SD22A/0347

Additional Information

Client  
Romeville Developments Ltd  
Project  
Stoney Hill Road, Rathcoole, Co. Dublin

Drawing  
PROPOSED CENTRAL AVENUE DETAILS

PROPOSED CONTEXTUAL 5 - SITE SECTION NORTH SOUTH  
SCALE 1:100

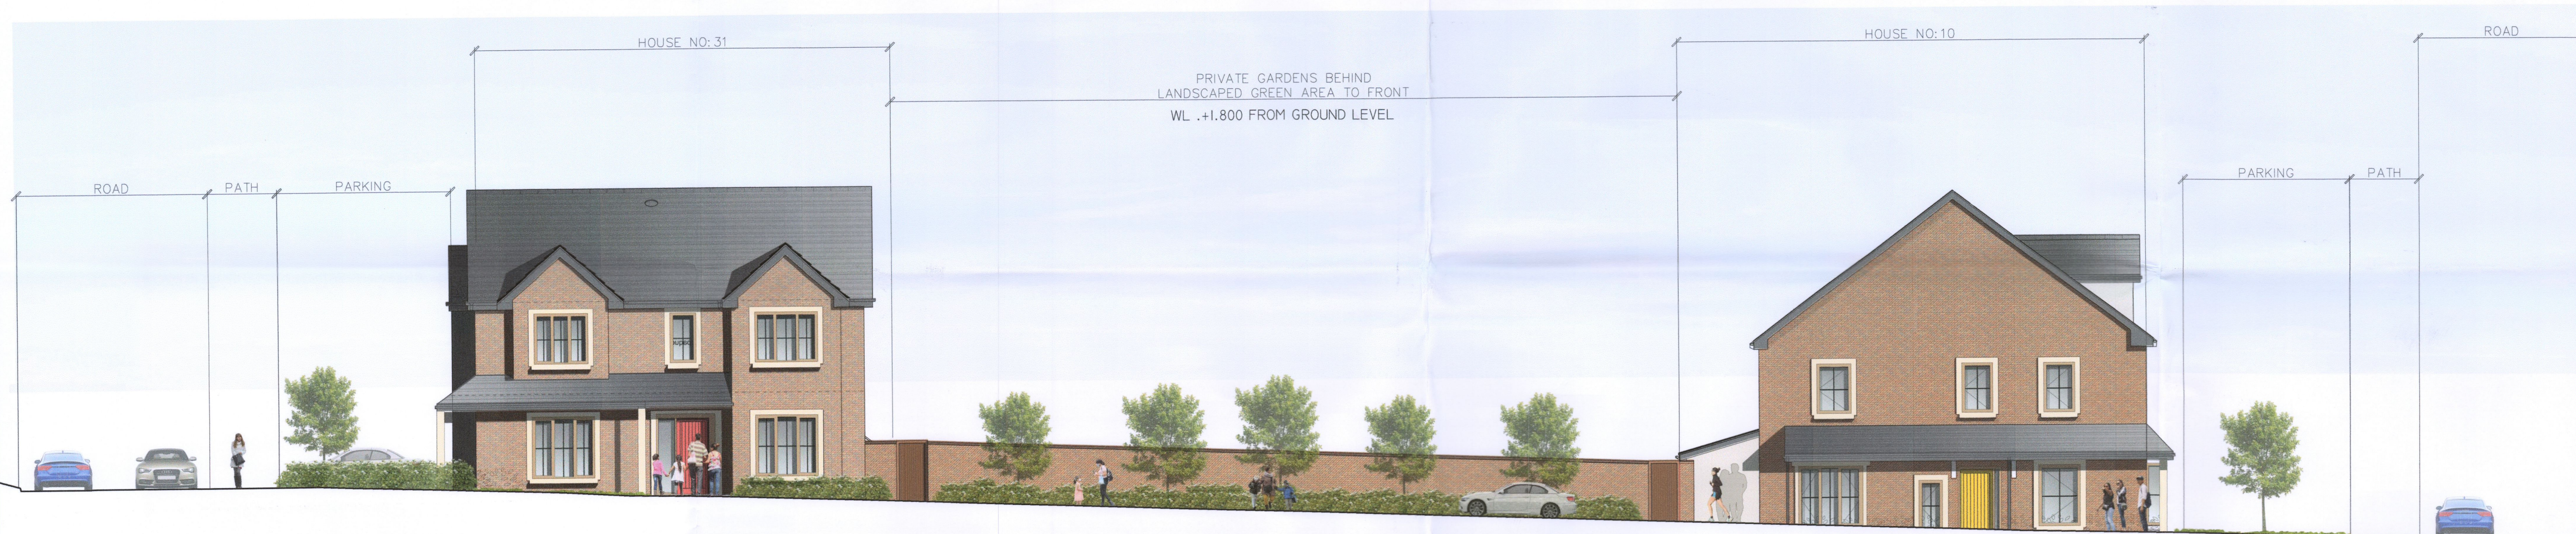
(b) The submitted site section shows that the garden walls would not be tall enough to ensure privacy at some points along the central street.

(b) The submitted site section has been amended to show the garden walls are all to be 1.8m tall to ensure privacy at some points along the central street. This is illustrated on in the drawing above.

PROPOSED CENTRAL AVENUE - ELEVATION  
SCALE 1:100

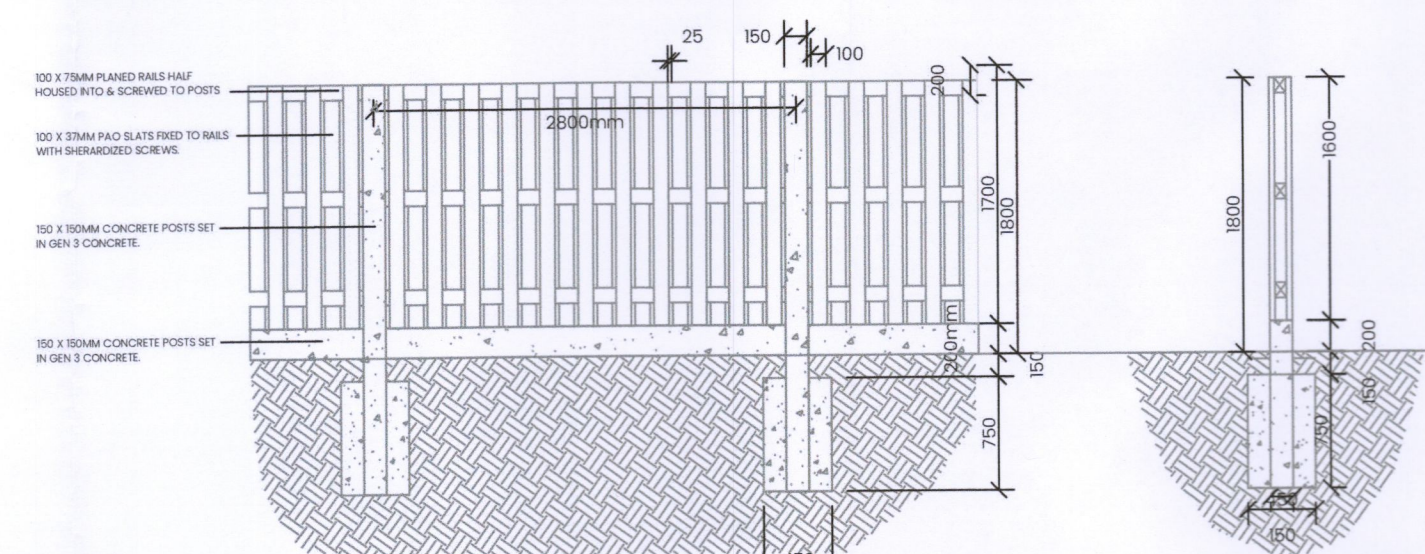
(a) The applicant should consider alterations to the east and west ends of each block to provide wraparound units and west/east-facing mid block units, minimising instances where gardens side/back onto the street, and maximising active frontage onto streets and open spaces.

(a) The proposed scheme includes dual frontage wraparound units (units L2, F3 and F4) to the east and west ends of each block as illustrated on the proposed site layout plans 2227-(P)107A-Proposed Site Layout 1-500. The photo montage above illustrates the wrap around units along the central street where they maximise the active frontage. The locations of the entry points are also noted on the above drawing.

Typical post and panel fence detail 1:50

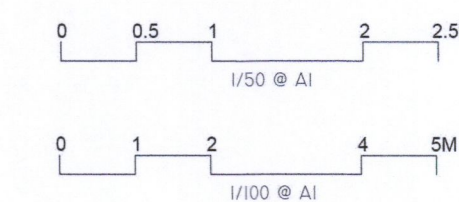
(c) Additional site sections or landscape details should specify the proposed boundary treatment between the rear gardens, specifically whether larger retaining walls are being utilised to step down the hill.

(c) All boundary treatments between rear gardens to be 1.8m high, select finish, solid post and rail fence. Select finish to perimeter boundary walls of private open space, refer to 2227-(P)107A-Proposed Site Layout 1-500 for more detail. Rear gardens to be levelled and graded where possible to avoid the need for retaining walls. In instances where retaining walls are required, they are to be designed and constructed to Structural Engineers specifications in accordance with current regulations in relation to retaining walls.
